ADDENDUM #5

Rye City School District

Osborn Elementary School

Midland Elementary School

THE RYE CITY SCHOOL DISTRICT
ADDITION AND RENOVATIONS
AT MIDLAND ELEMENTARY SCHOOL
RYE, NEW YORK

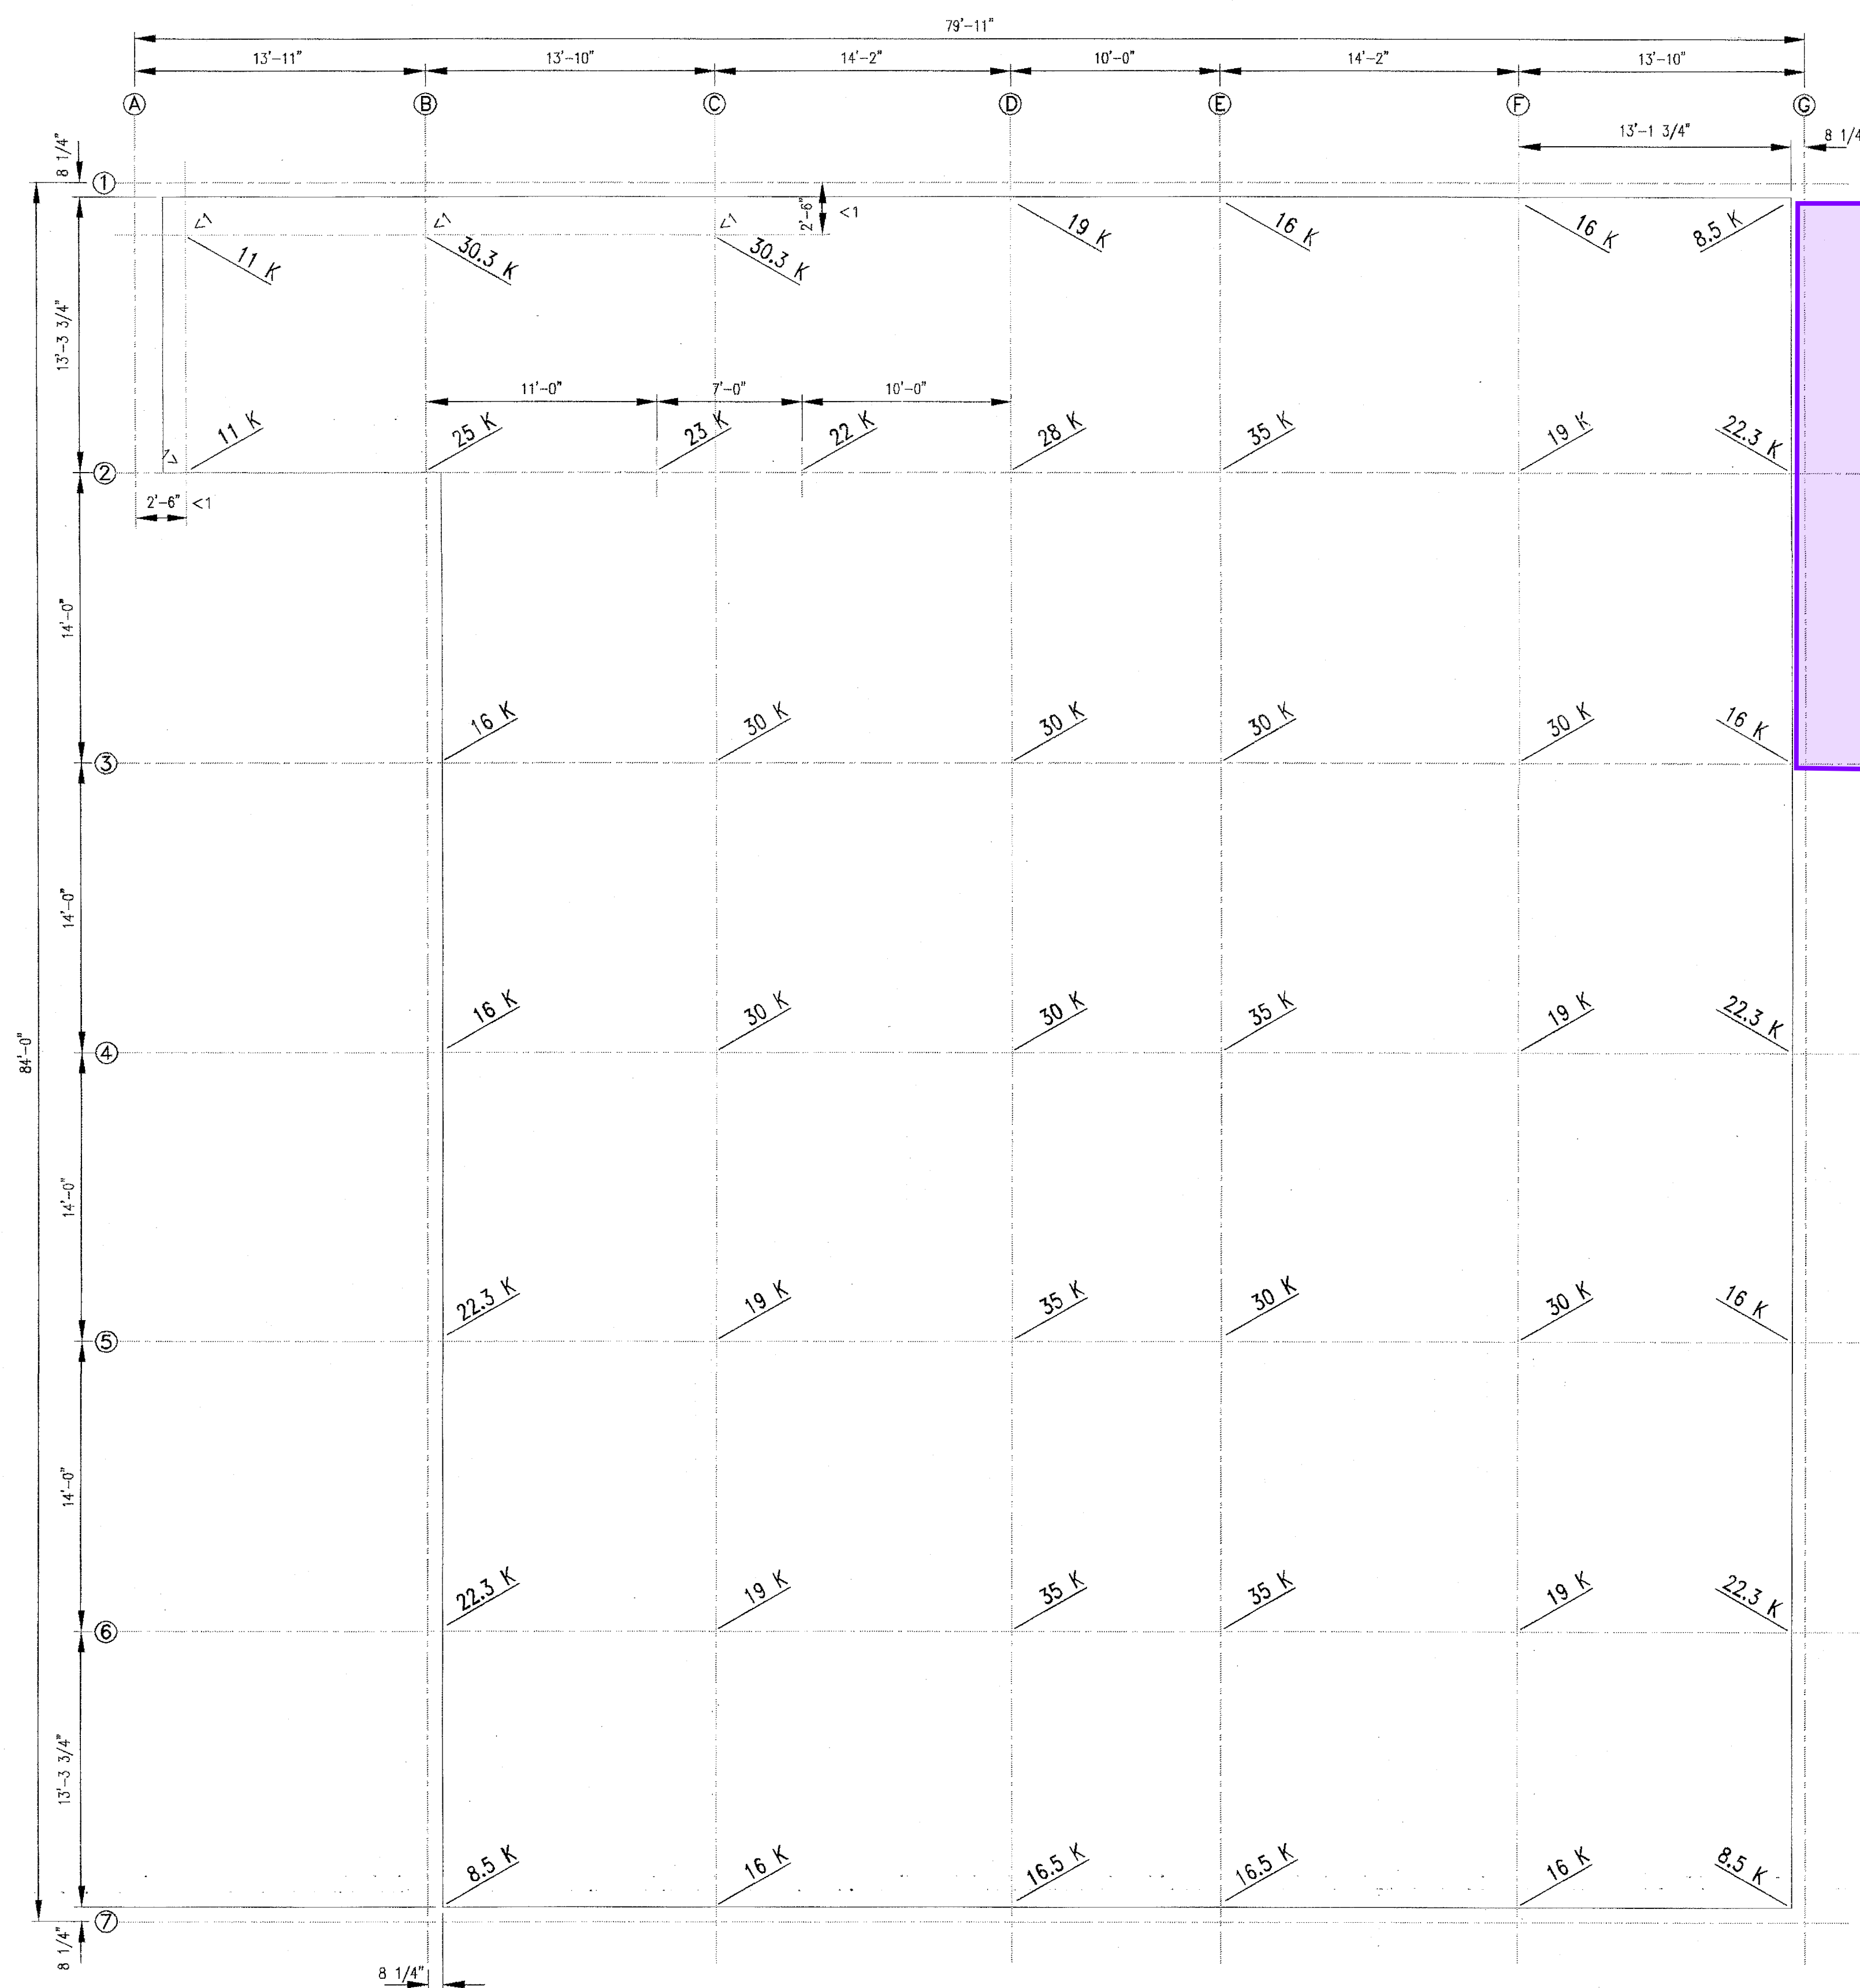
Additional reference regarding the framing of the existing building:

The proposed addition is going next to the 2005 addition. The original drawing package for this addition that shows the roof framing for the area adjacent to the proposed addition is provided in this addendum. These have been marked up to show where the proposed addition is in relation to the existing building to assist and clarify with estimating required fireproofing.

OVERALL ROOF FRAMING PLAN

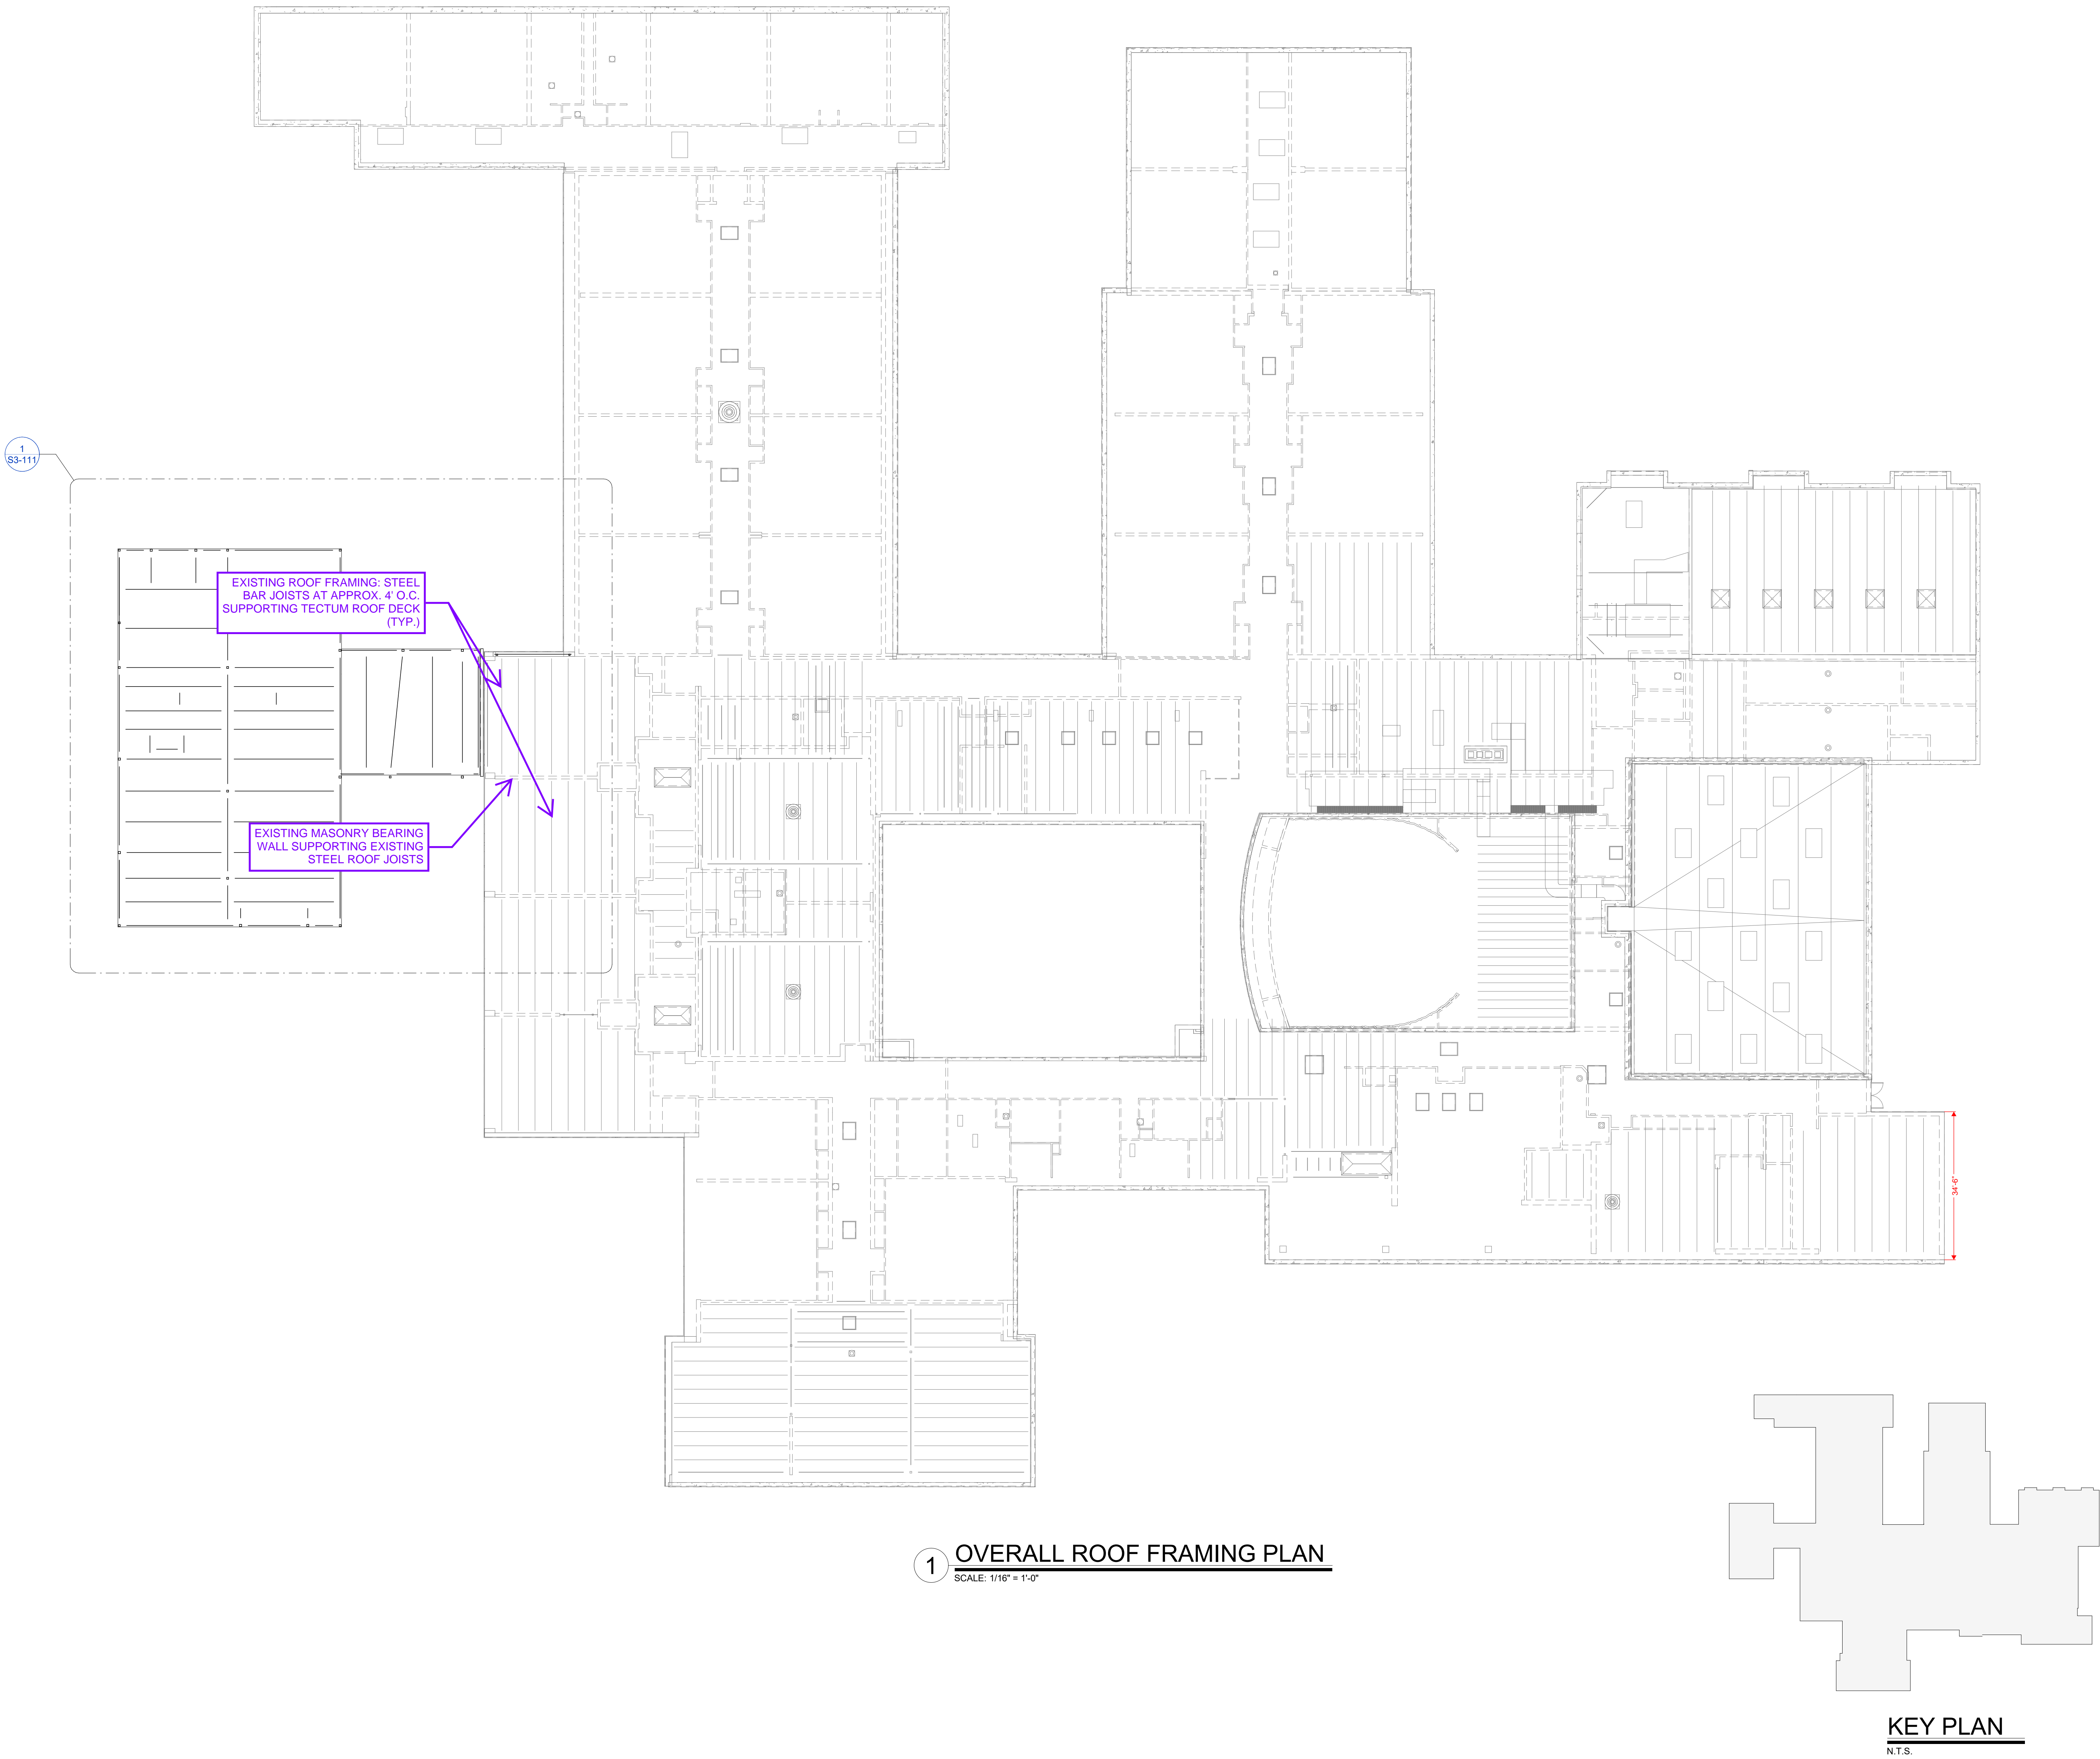
Additional reference regarding the framing of the existing building:

The roof framing for the area adjacent to the proposed addition is open web steel bar joists at approx. 4 feet on center supported on existing masonry bearing walls. A drawing showing the overall roof framing plan is provided in this addendum. Additional notes have been added to clarify the structure and assist with estimating required fireproofing.
